GREAT LAKES INDIAN FISH AND WILDLIFE COMMISSION

December 14, 2015

Comments on NorthMet FEIS and Section 404 permitting

Re: Mine site groundwater model formulation and calibration.

Figure 2 - Profile of the water table between the upper Partridge and the P-M pits under 2 scenarios of water level in the pits.

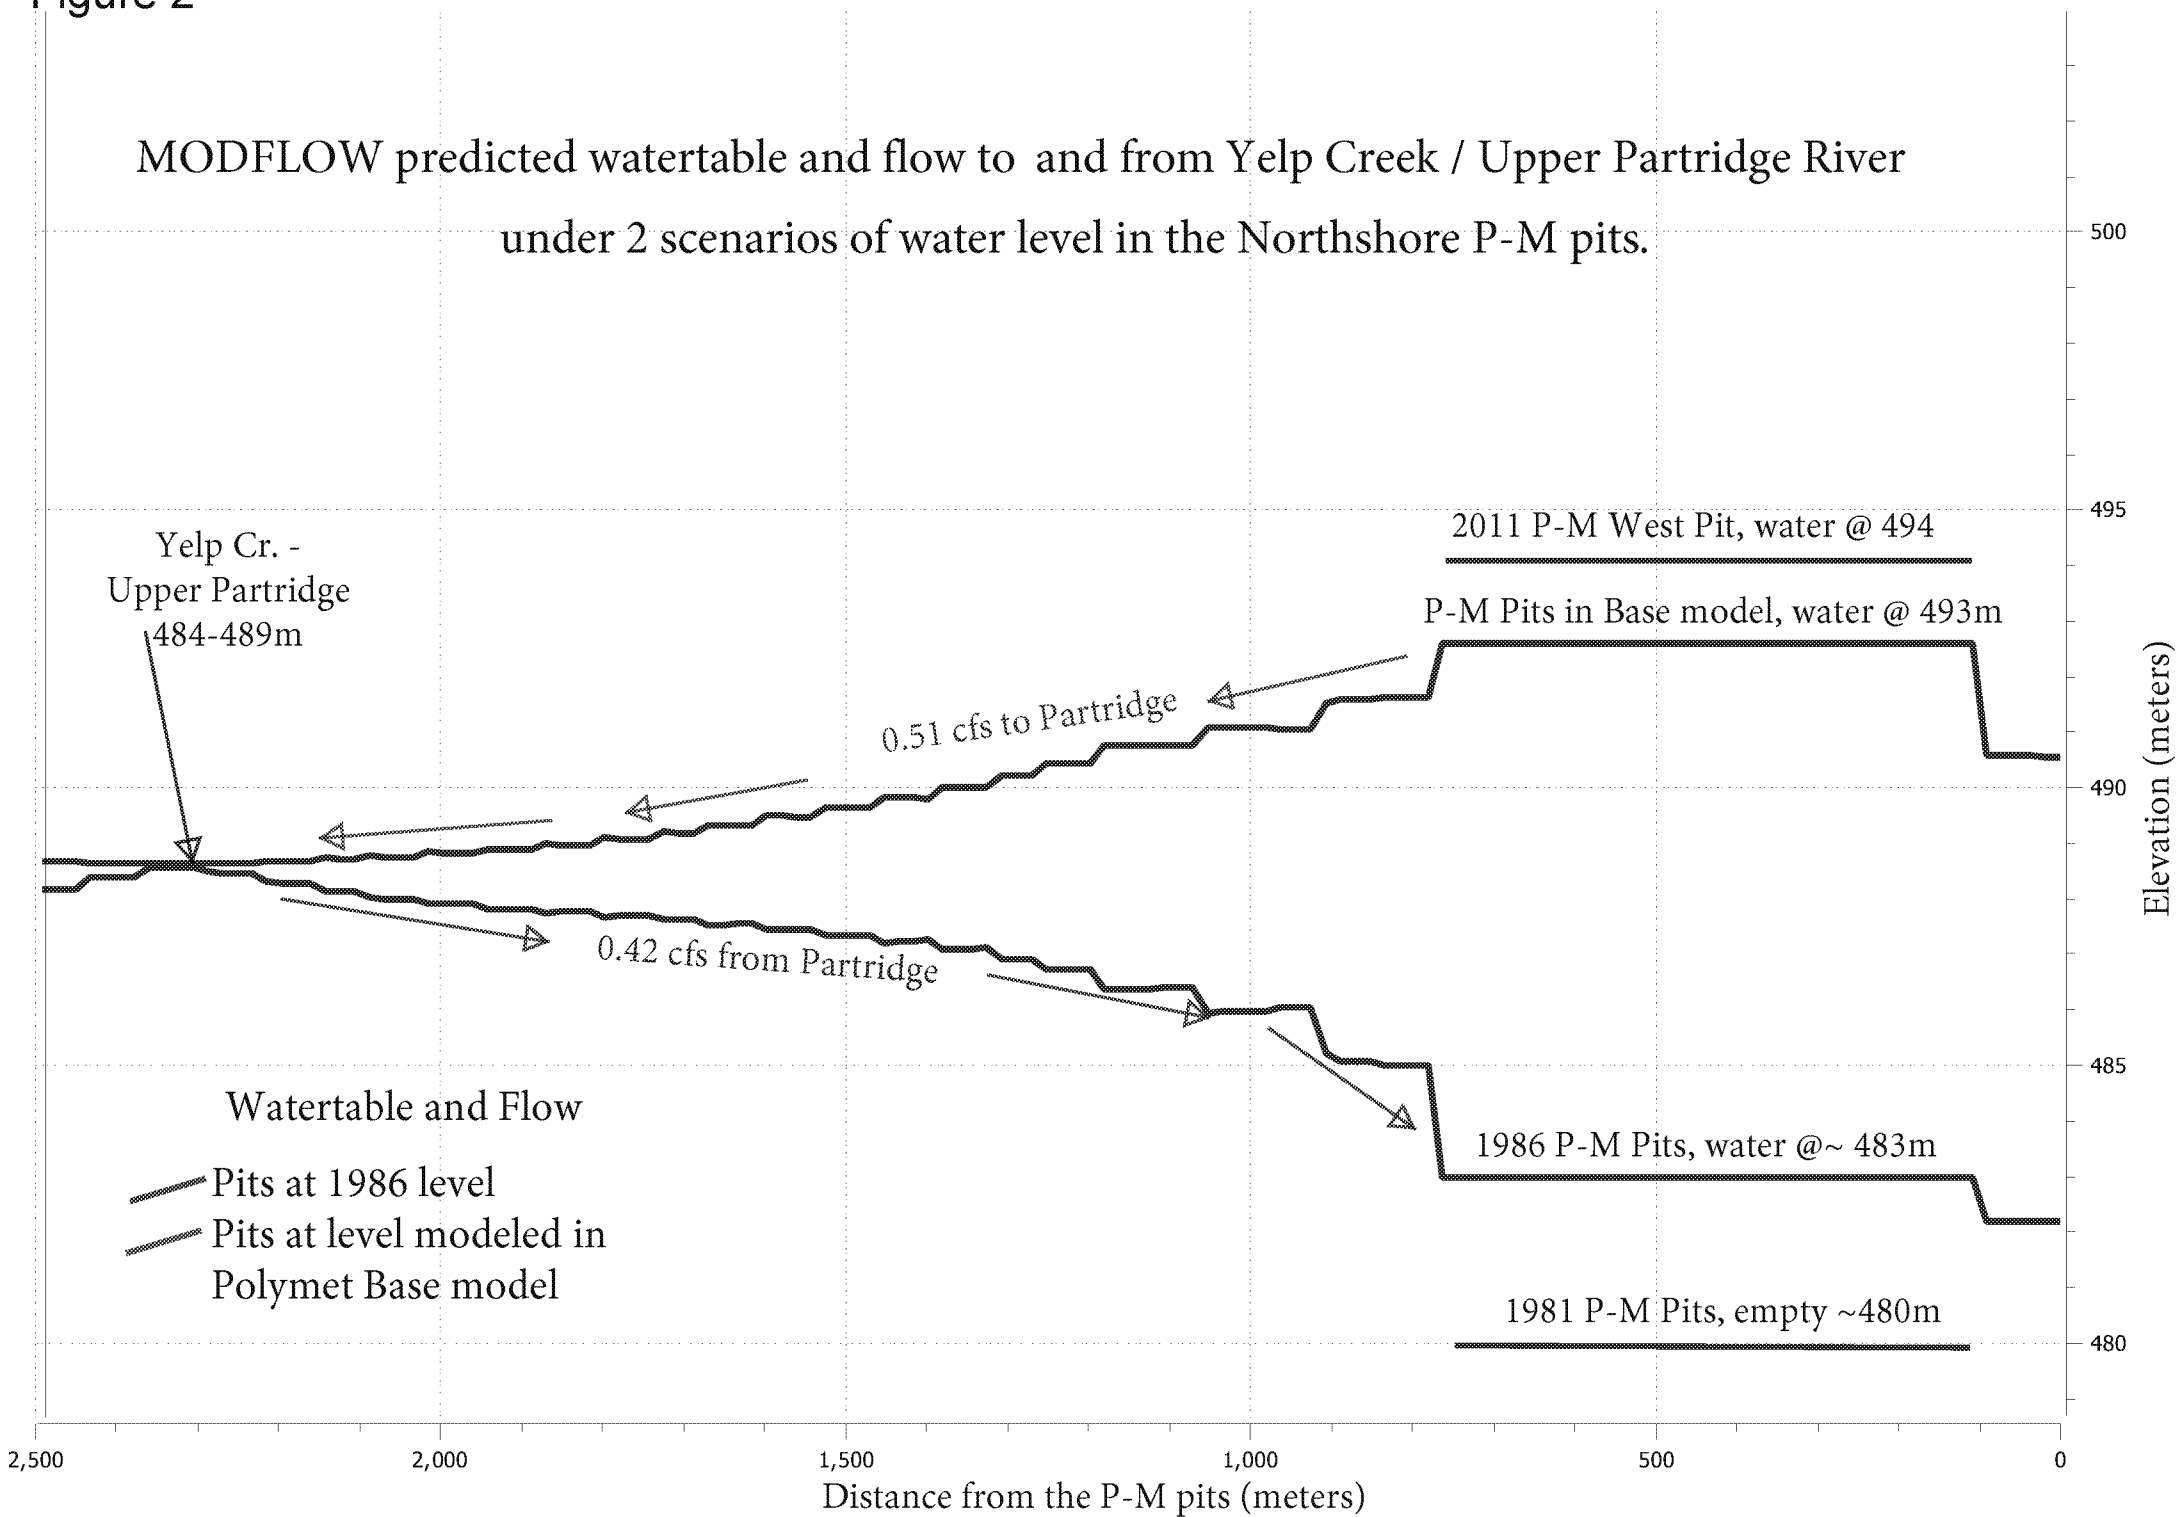
Attached is a figure that shows the predicted water tables and groundwater flow between the upper Partridge and the P-M pits when the P-M pits are set at different levels (attached as Figure 2). In red are the project model results used in recent and past project reports. In those models the P-M pits are assumed to be at their 1996 elevation of 493 meters (1616 feet). The 483 meter model (in purple) is the same as the project model except that the water levels in the P-M pits, that are adjacent to the upper Partridge, are set to 483 meters. An average pit water elevation of less than 480 meters appears to be the correct elevation for the calibration period of 1979-1988 (attached as Table 1). Calibration and use of the MODFLOW model with the P-M pits erroneously set to the unusually high conditions in 1996 (493 meters) is a problem for the following reasons:

- The average water level in the P-M pits, when the baseflow at SW003 was estimated to be 0.51 cfs (i.e. in the 10 years of 1979 to early 1988), was actually more than 13 meters lower than the 1996 levels, at less than 480 meters.

As the diagram shows, with the pit water levels that occurred in November of 1986 (i.e. ~483 meters), the upper Partridge would have been losing water to the pits and would have had no baseflow. The water table would have sloped down northward from the Partridge River toward the P-M taconite pits. This is because the riverbed of the upper Partridge River is at 486-489 meters elevation, whereas the water levels in the adjacent P-M pits were at approximately 483 meters elevation in 1986. Average water levels in the P-M pits during the 10 years for which baseflow was calculated (1979-1988) were *even lower* than the 483 meter elevation found in 1986.

The red stair-step line in the figure is the water table between the upper Partridge R. and the Peter-Mitchel taconite pits when the pits are at 492.6 meters elevation (1616 feet). Water is flowing from the pits to the upper Partridge R.

The purple stair-step line is the water table between the upper Partridge R. and the Peter-Mitchel taconite pits when the pits are at 483.4 meters (1586 feet) elevation (the elevation that they had in 1986). In the 483.4 meter model run, water is flowing from the upper Partridge R., to the P-M pits.

Water Levels in Peter-Mitchel Area003-east pit

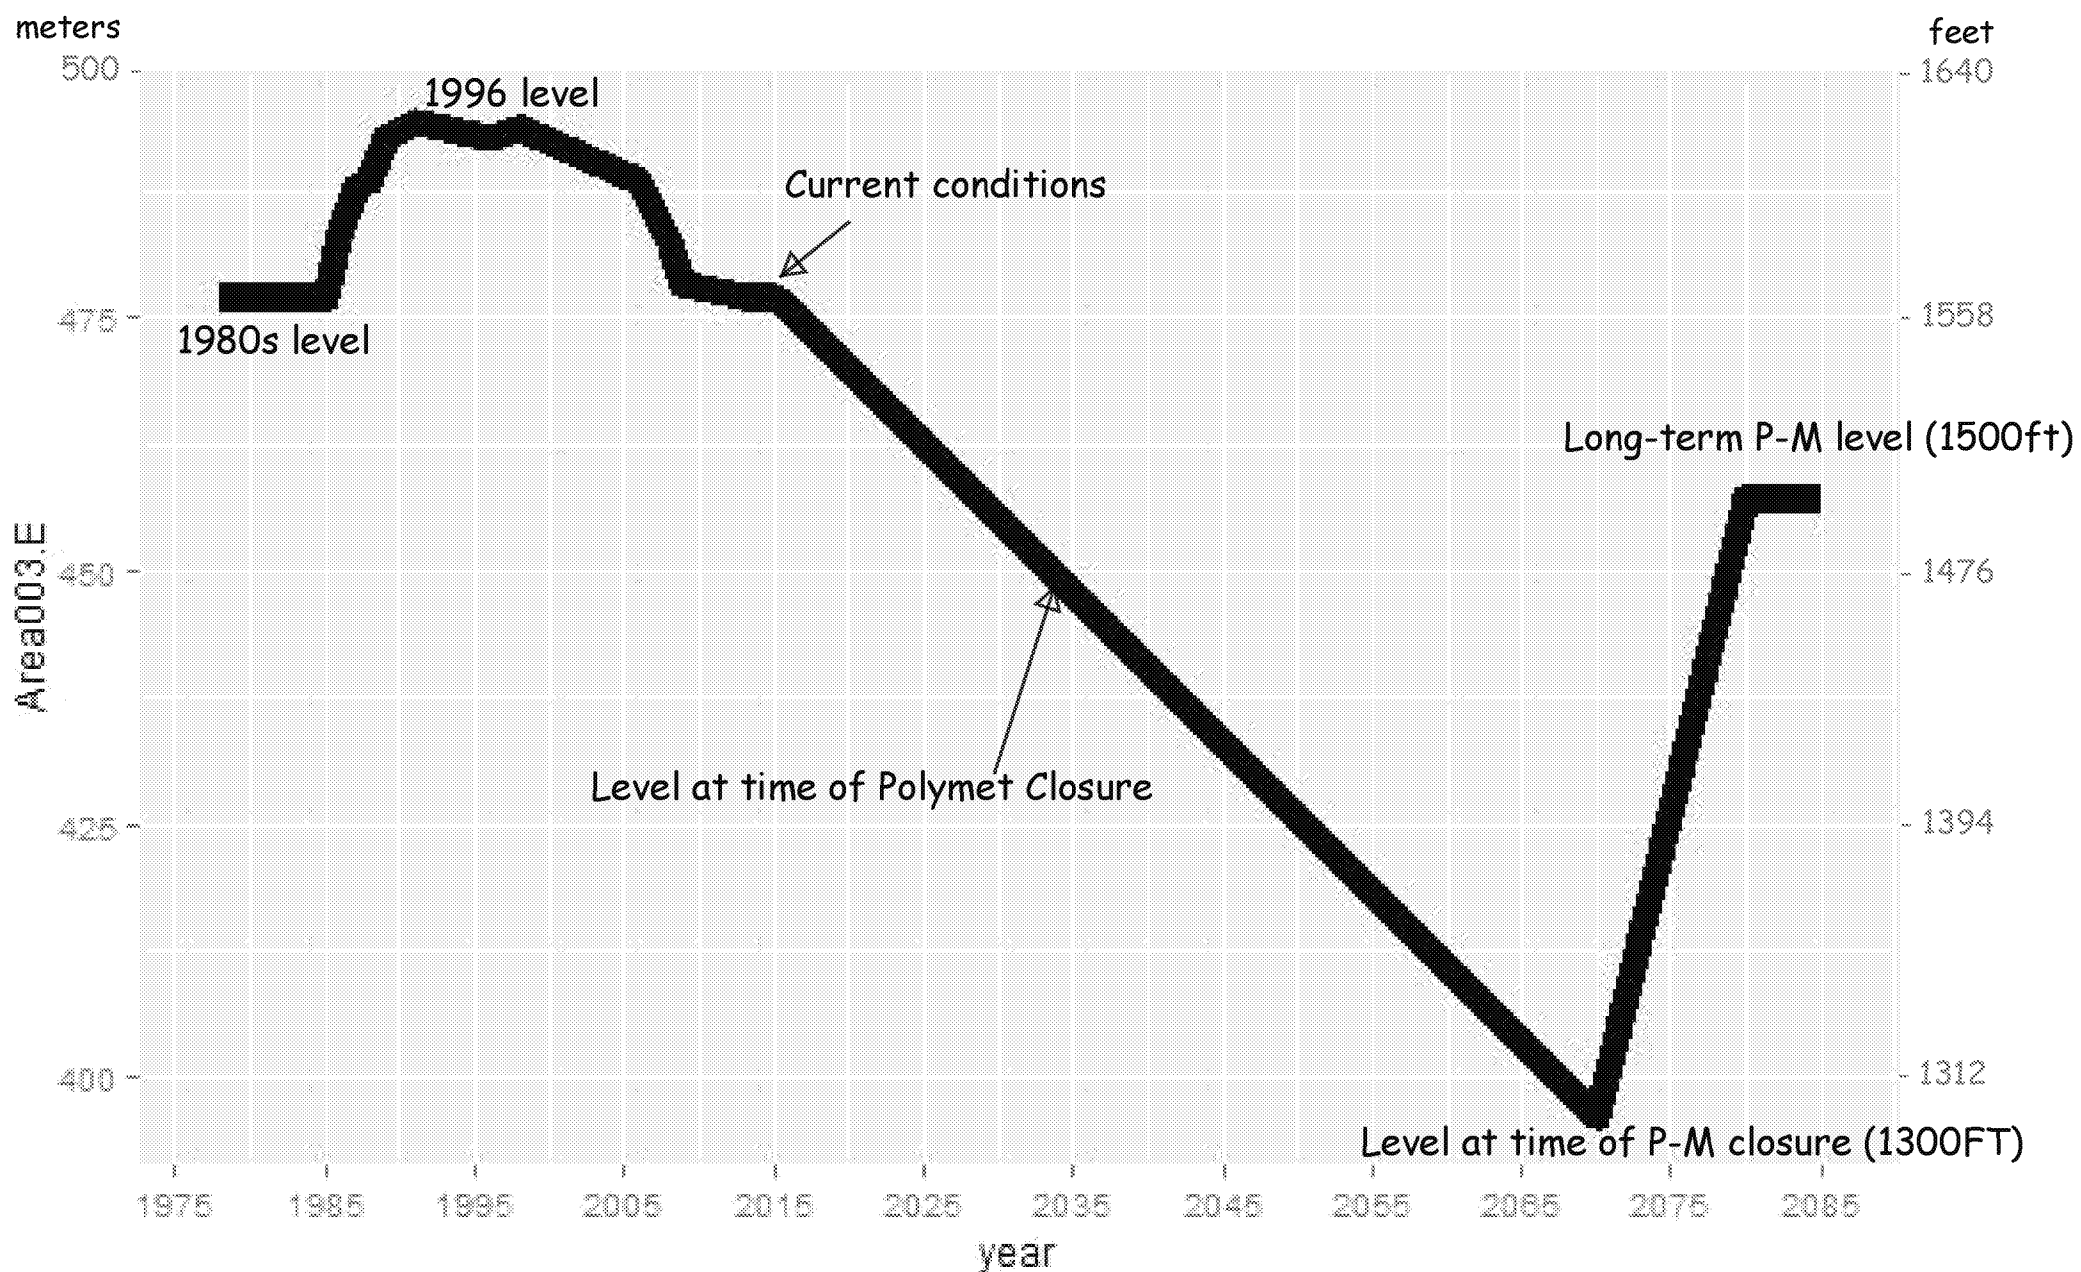
Water levels in the P-M Area003-East pit (Table 1 and Figure 5) increased from an elevation of less than 478 meters in 1979 to 488 meters in the fall of 1987. During most of that period the Area003-East pit was empty, i.e. less than 478 meters elevation. In contrast, the 1996 water level used for the Area003-East pit during Barr Engineering's model runs was 492.6 meters (1616 feet) elevation. The 1996 water level used for the P-M pits as a boundary condition in the modeling was abnormally high. Such high levels did not occur in the 1980s, do not occur now and will not occur at closure.

The significance of this is that using the high 1996 Peter-Mitchel pit water levels during calibration is likely to have resulted in restrictive (i.e. low) formation conductivities and recharge in order to force the model to match calibration targets. In order to conservatively estimate maximum PolyMet project pit inflows, the models should have been calibrated with realistic P-M water levels and only during pit inflow predictive runs should the P-M pit water levels been raised to their likely maximum level such as that found in 1996. Such procedures for worst-case scenario analysis (Anderson et al. 2015, Section 10.4.1 Scenario Modeling) is basic to hydrologic modeling.

Figure 2 GLIFWC Summary Illustration from June 18, 2015 Correspondence

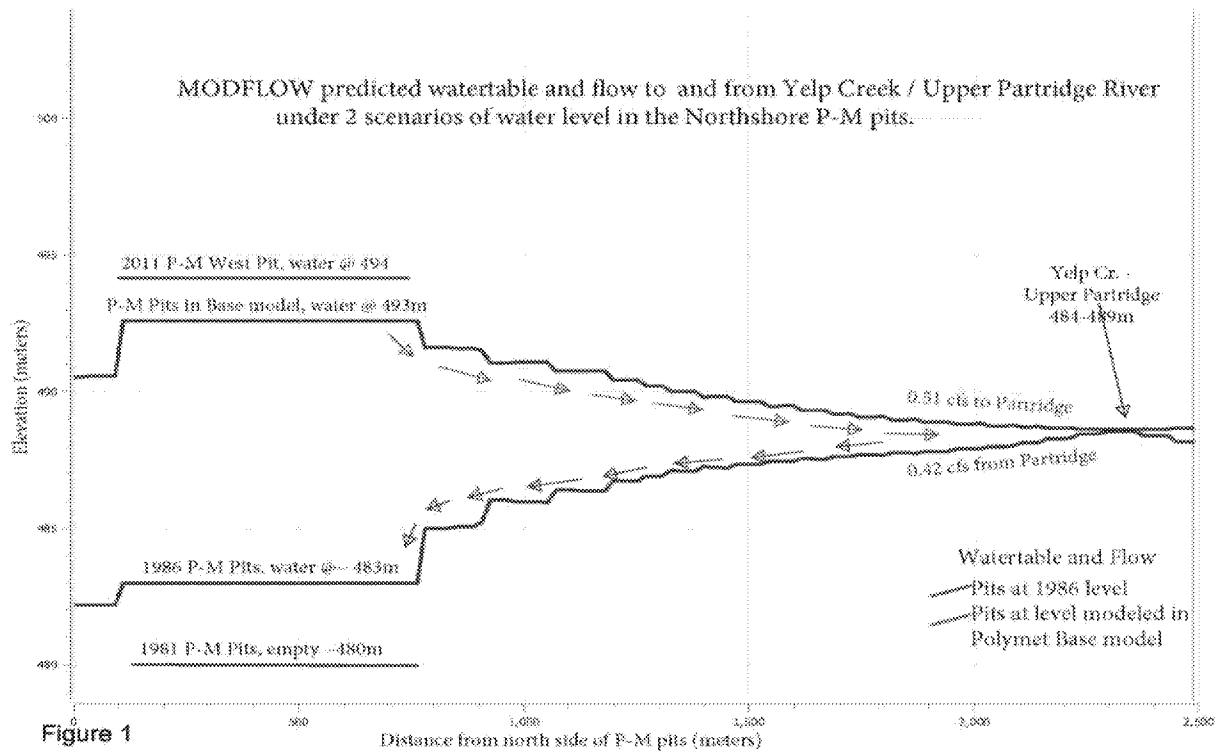
The Co-lead Agencies' review of the summary illustration attached to the GLIFWC letter (Figure 2 herein) suggests that during the 1980s, the Northshore pits intercepted approximately 0.93 cfs of groundwater that otherwise would have become groundwater baseflow to the Partridge River. The Co-lead Agencies further interpret the GLIFWC line of reasoning to suggest that groundwater baseflow at SW-006 could currently be 0.93 cfs higher than the value listed in Table 1, and this would give an Upper Partridge River groundwater baseflow yield of 0.064 cfs/mi², which is approximately 18% higher than the FEIS value (0.054 cfs/mi²). Applying this higher groundwater baseflow yield (derived from GLIFWC's assumptions) to the other MODFLOW calibration stations would lead to the values summarized in Table 2.

The Co-lead Agencies do not consider GLIFWC Option #1 to be a viable option because other calibration data, such as measured groundwater levels in surficial deposits and bedrock, would be limited or nonexistent for the mid-1980s time period. The Co-lead Agencies do consider GLIFWC Option #2 to be a workable approach for investigating the effect of higher groundwater baseflows on predicted water quality and quantity effects associated with the NorthMet Project Proposed Action. If pursued, GLIFWC Option #2 would increase the groundwater baseflows at all locations used to calibrate the MODFLOW model by a factor of 2.5 to 3.5 times higher than the groundwater baseflows used to calibrate the FEIS model (listed in Table 1). This is also much higher than the approximately 18% increase interpreted from the illustration attached to the GLIFWC letter (See Figure 2).
